Comment Set B.19: B&C Land and Water, LLC

**Re: Antelope-Pardee 500 kv Transmission Project Proposed by
Southern California Edison Company – Application No. A.04-12-007**

Response to Comment Set B.19: B&C Land and Water, LLC

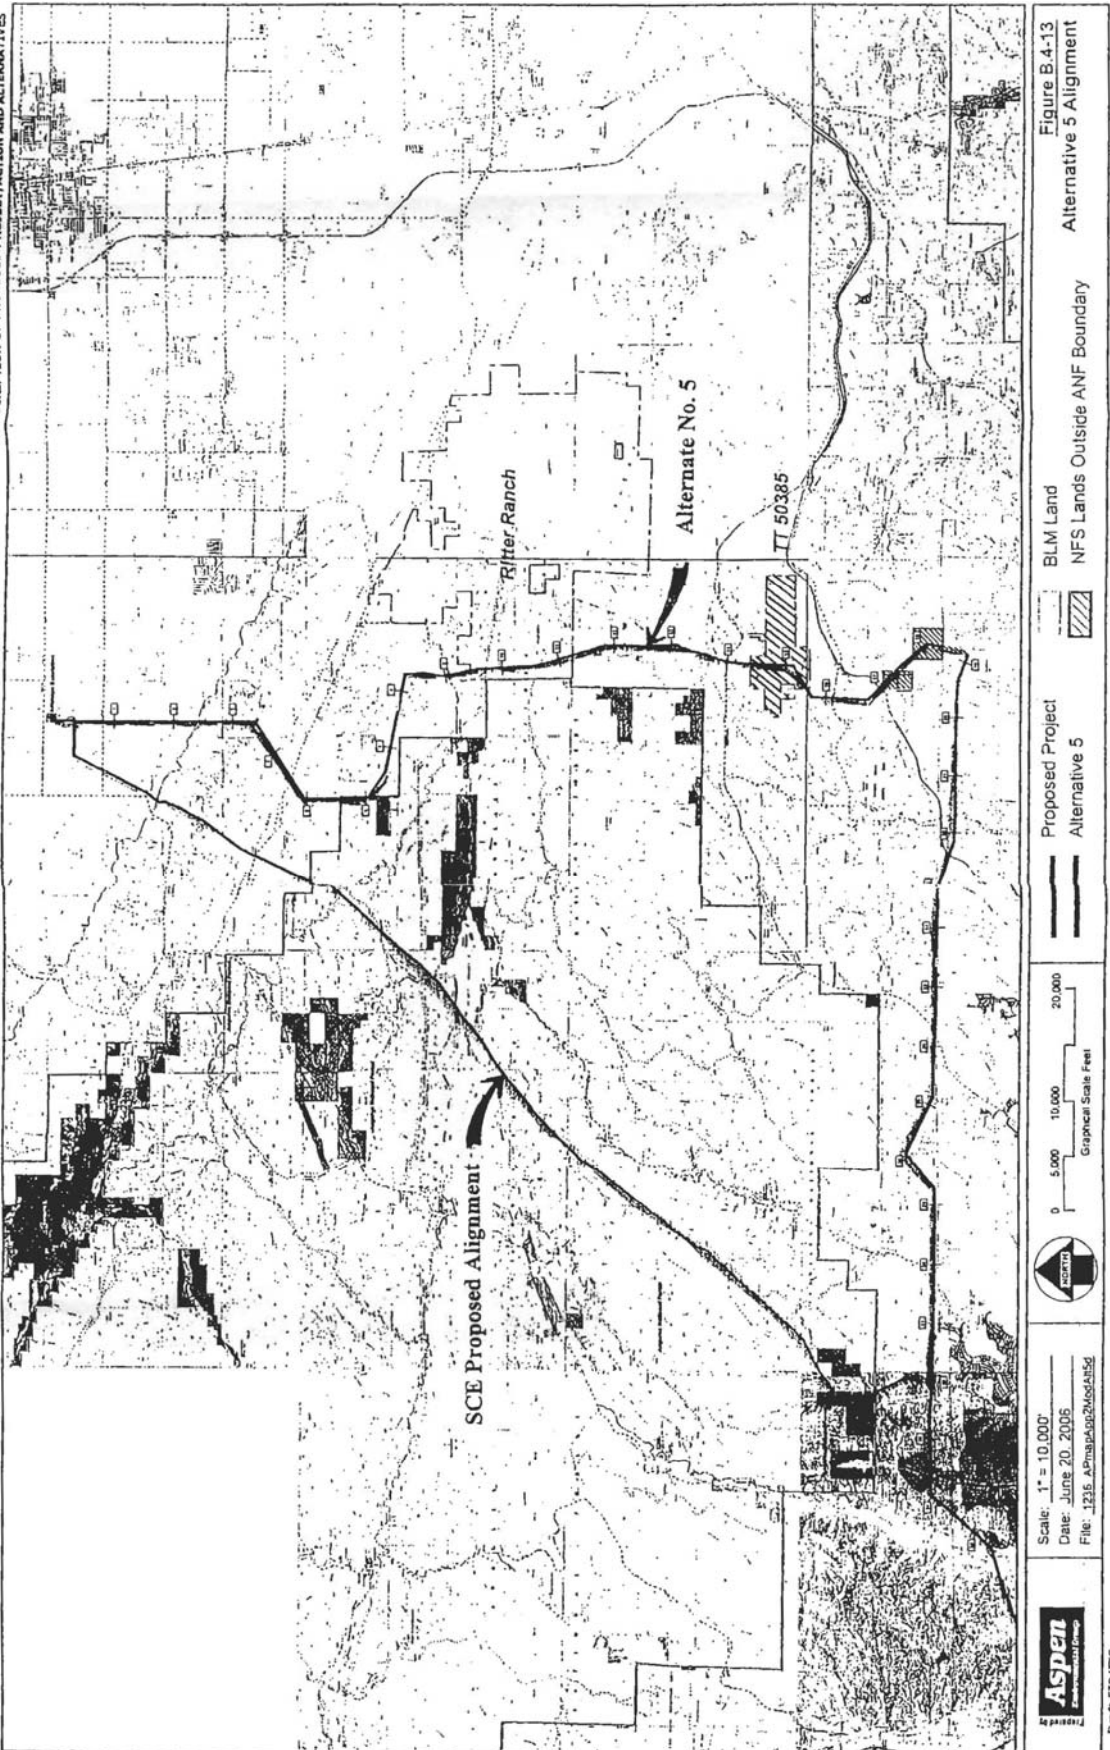
- F. Referring to the attached exhibit, the Draft EIR/EIS does not address the impacts to the remaining homes within “B&C”s” development. The balance of the remaining homes and the view sheds those homes enjoyed would be destroyed and would result in a reduction in home values. In some cases, it could result in a situation where the mortgage debt on the home could exceed the market value of the home.

- C. The Draft EIR/EIS must address the fact that “B&C”s” development takes public access from Valley Sage Road and Sierra Highway (See Attached Exhibit). The location of the “Project” would create a sense of isolation of public services of the entire westerly portion of “B&C”s” development;

B.19-1 Impacts to Tract Map No. 50385 are discussed in Section C.9.10.2 (Impact L-3) of the Draft EIR/EIS. It is stated that “Alternative 5 would also be sited across the approved Agua Dulce Residential Project (TR 50385), and as a result would preclude the development of planned land uses within the ROW”. Impacts are determined to be significant and unavoidable (Class I). Tract Map No. 50385 is also listed in Table B.5-2, “Cumulative Projects List: Notable Approved and Pending Projects Greater Than Five Miles from the Proposed Project” and, therefore, has been included in the discussion of cumulative impacts of the Project.

Regarding assessment of the specific impacts of Alternative 5 on TR 50385, it is not appropriate or necessary for the EIR/EIS to present impacts by parcel or per property. The level of discussion that has been included in the EIR/EIS is appropriate to comply with CEQA and NEPA. Please note that CEQA and NEPA require that impacts be evaluated based on conditions as they existed at the time the Notice of Preparation (NOP) was published (June 2005) compared to conditions in the future with the implementation of the proposed Project or the alternatives. Consistent with this requirement, it would not be appropriate for the EIR/EIS to indicate that 125 homes and 450 residents would be displaced by Alternative 5 when these homes do not yet exist. Similarly, it would not be appropriate to identify the other “impacts” listed in the comment that describe effects to a development that does not yet exist. However, the adverse effects that Alternative 5 would have on this approved development project have been noted (see Draft EIR/EIS Section C.9.10.2), and the make decision-makers at the CPUC and USDA Forest Service will be made aware of these consequences.
